> Product Change Notification (PCN)

Product group:	MINISKIIP II	Rev.:	0
No.:	PN19-109	Change of PCB guiding pin diameter for MiniSKiiP 2nd generation housing size 1 and 2	18 Dec 2019

Subject of change: Change of PCB guiding pin diameter

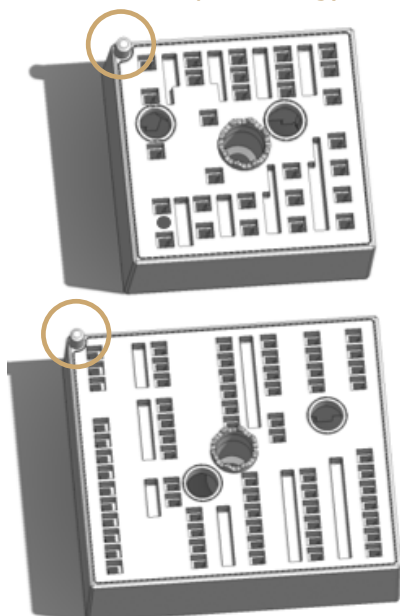
- Change of PCB guiding pin diameter from 2.7mm back to 3.0mm (same as former Noryl housing) to harmonize housing dimension

Reason for change: Customer request, harmonization

Impact of change: No impact: The recommended PCB hole diameter in the MiniSKiiP data sheet remains unchanged
